# **DRAWING AMENDMENTS:**

#### REMARKS

**Appendix A**(Replacement Sheet Showing Figure 14)

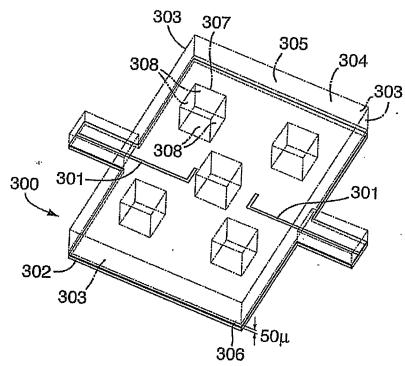
The examiner objected to the drawings for lacking a Figure 14. A replacement Figure sheet including a new Figure 14 and original Figure 16 is attached to this Reply. Figure 14 does not add any new matter to the application.

Attached at Appendix A is a New Sheet including Figures 14 and 16. Figure 14 is newly added to the application while Figure 16 was previously part of the application.
